**DEPARTMENT OF TRANSPORTATION  
FEDERAL AVIATION ADMINISTRATION  
EASTERN REGION**

**WRITTEN REEVALUATION AND RECORD OF DECISION  
FOR THE ENVIRONMENTAL ASSESSMENT FOR THE  
CENTRAL TERMINAL BUILDING REDEVELOPMENT PROGRAM AT  
LAGUARDIA AIRPORT  
QUEENS, NEW YORK**

**DECEMBER 30, 2015**

**Figure 3**  
**Overlay of Proposed Design Changes and 2014 Design**

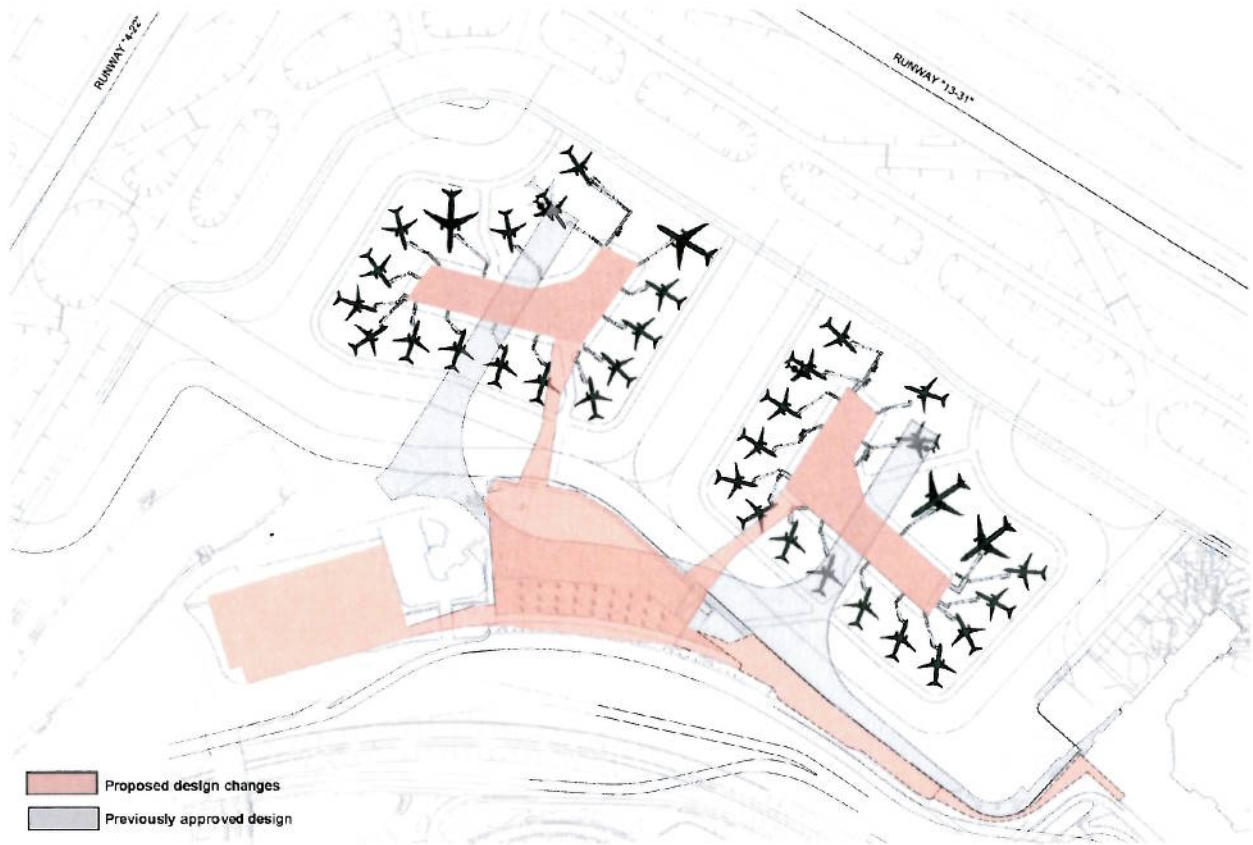
The proposed design changes redefine the overall configuration of the terminal elements and consist of a reconfigured headhouse and two midfield concourses (Fig 1), rather than the 2014 Design of a headhouse directly connected to two pier concourses (Fig 2). The two midfield concourses are connected back to the headhouse by means of pedestrian bridges spanning over taxilanes. The gross floor area of the proposed design change is 1,457,697 square feet, representing a 9.51% increase from the 2014 Design. Due to the addition of a fourth floor within the terminal, the footprint of the redesigned CTB is smaller than the 2014 Design even though it offers more square footage. The building height of the redesign CTB is higher than what was proposed in the 2014 EA; however, as design advanced following the 2014 FONSI/ROD, the 2014 Design would actually have been slightly higher than what is now proposed for the redesigned building. The design changes are overlaid on the 2014 Design in Fig 3.

**Figure 3-4. Updated West Garage Footprint (in comparison to 2014 EA)**

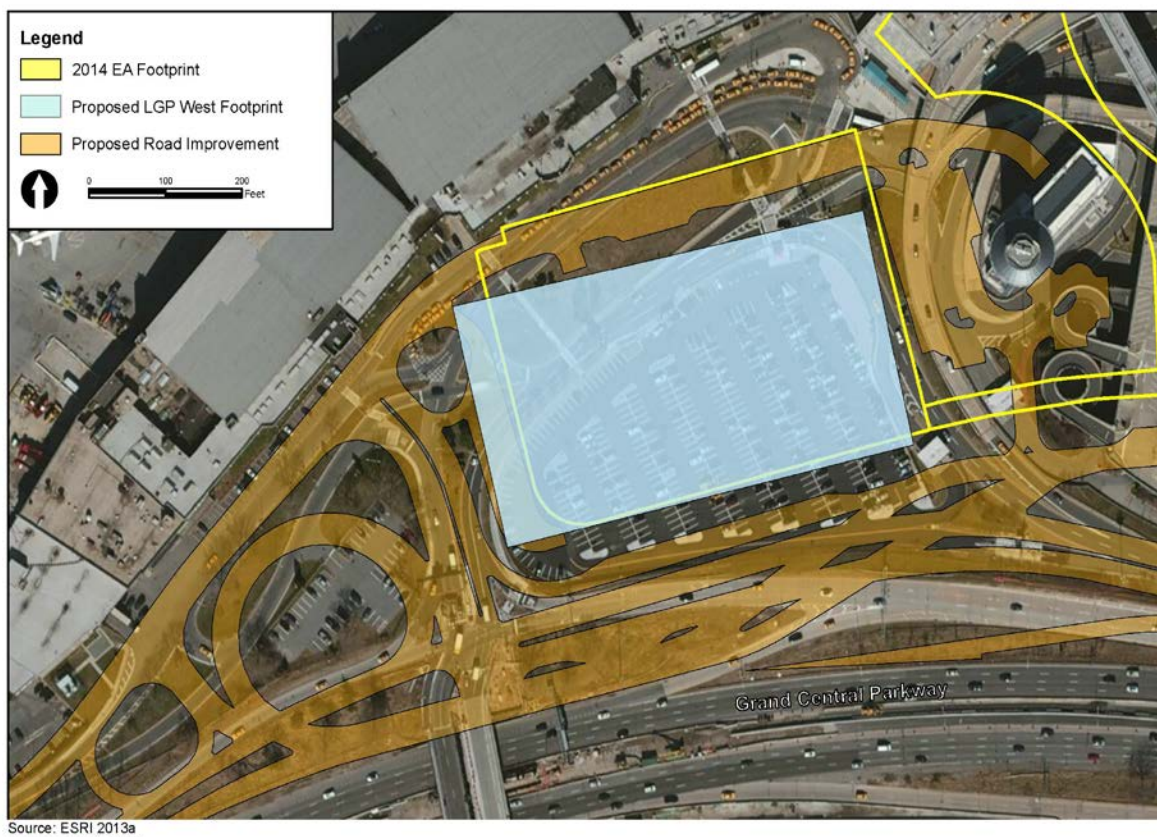
*Change: The new West Garage now provides 3,100 spaces on 7 levels based on additional information on parking demand gathered since the 2014 FONSI/ROD and the need to accommodate parking spaces displaced by the new taxi hold lot (discussed below). The garage was originally presented as a five level garage. There are five levels of elevated parking in the garage as well as parking on the roof and ground floors, for a total of seven levels of parking. The height of the garage remains the same (83 feet above ground level). The increase in 200 spaces is a result of full utilization of rooftop parking, as opposed to partial utilization of rooftop parking in the previously approved (2014) design. The rooftop parking would be shaded to meet security requirements. Design refinements since the 2014 EA was released shifted the garage's footprint roughly 35 feet to the west and reduced the footprint to the north by roughly 40 feet. The garage remains substantially similar in size and location, as demonstrated in Figure 3-4.*

**Figure 5-3b. Proposed Roadway Design for the proposed design changes**

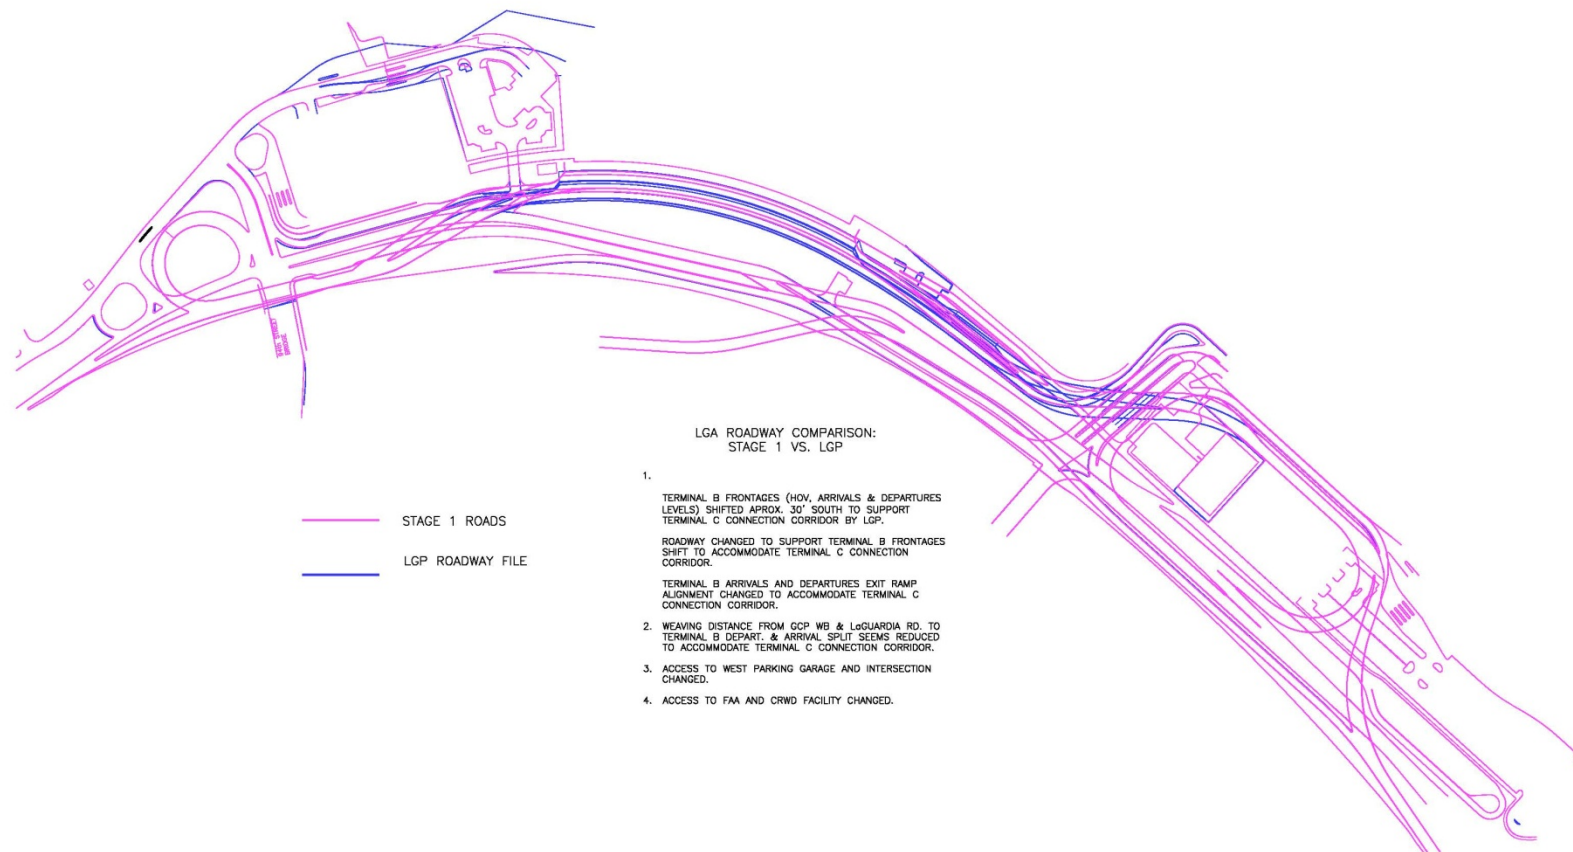
*Change: There would be minor changes to the on-airport roadway layout as a result of the proposed design changes (see Figure 5-3b).:*

Figure 5-8b. Community Viewshed Impacts (Proposed design changes)

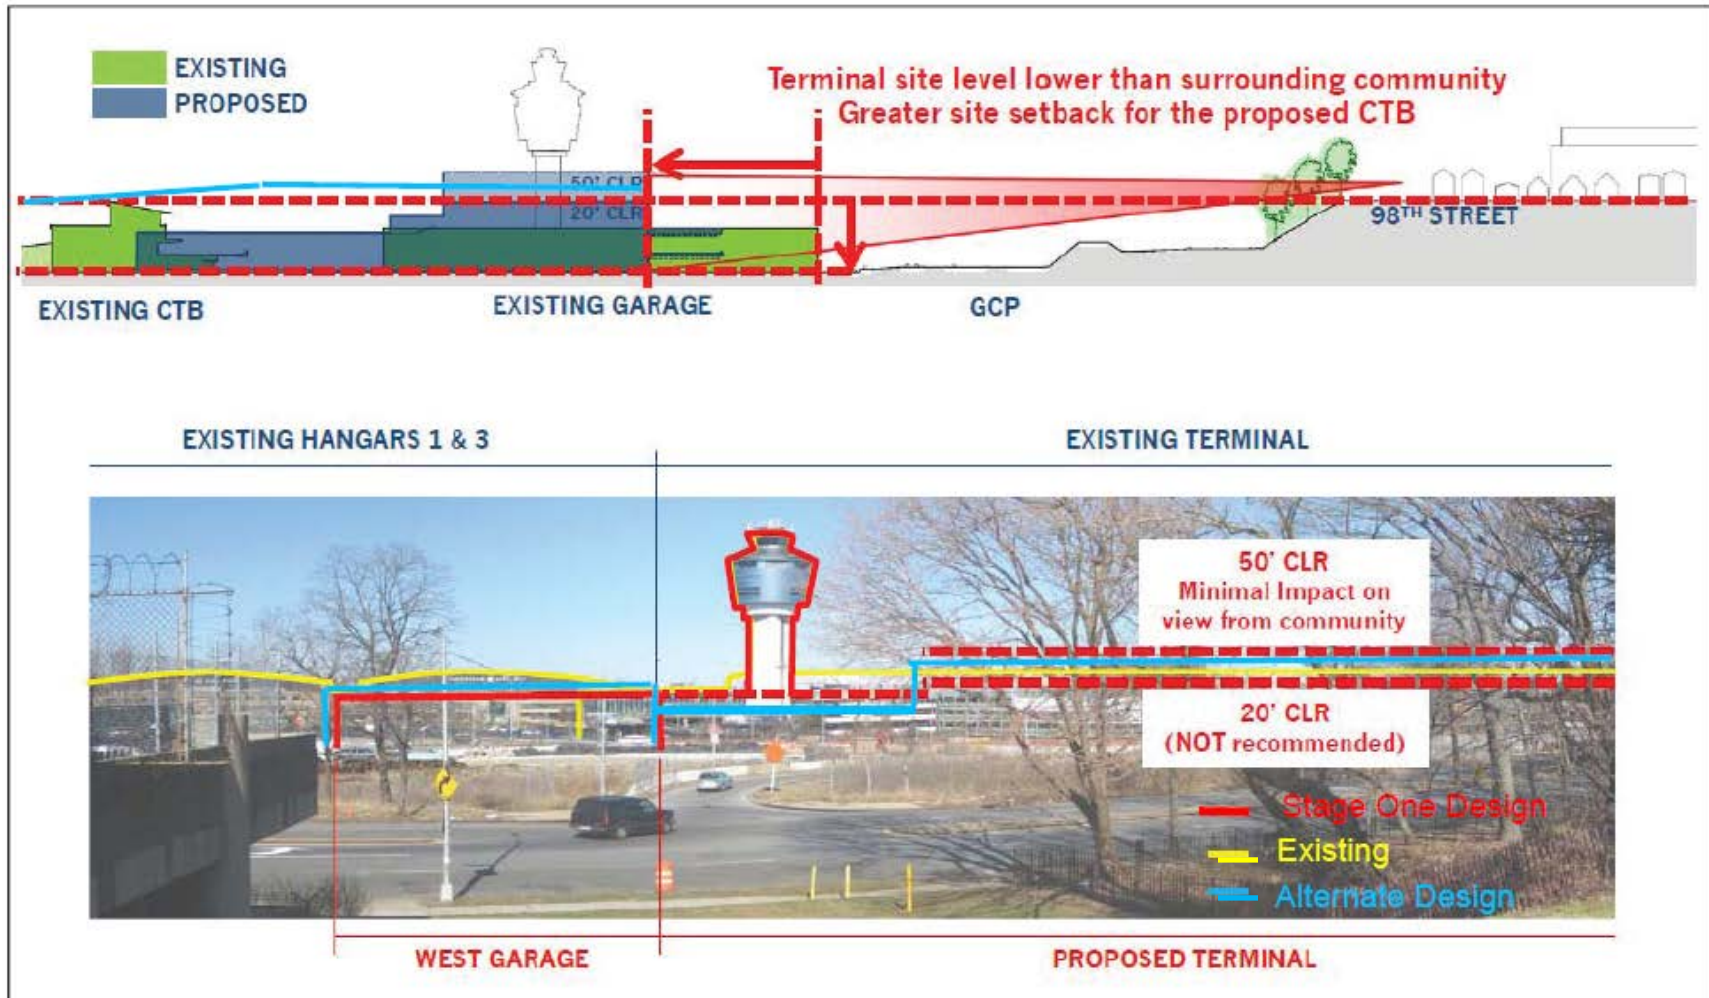
*Change: The revised **Figure 5-8b, Community Viewshed Impacts**, illustrates the proposed height and setback of the new terminal building in relation to the Grand Central Parkway and the community (based on the proposed design changes). As shown, the proposed terminal would be setback 170 feet further from the Parkway than the existing parking garage. A change of 30 feet versus the previously approved (2014) design (which was set back 200 feet from the Parkway versus the existing parking garage) would not be appreciably noticeable to pedestrians or drivers on the Grand Central Parkway and the terminal would still be setback further than the existing garage. Using a rendering of the proposed terminal, **Figure 5-9b** further demonstrates that the view of the Airport from the community would not be appreciably different with the proposed design changes.*
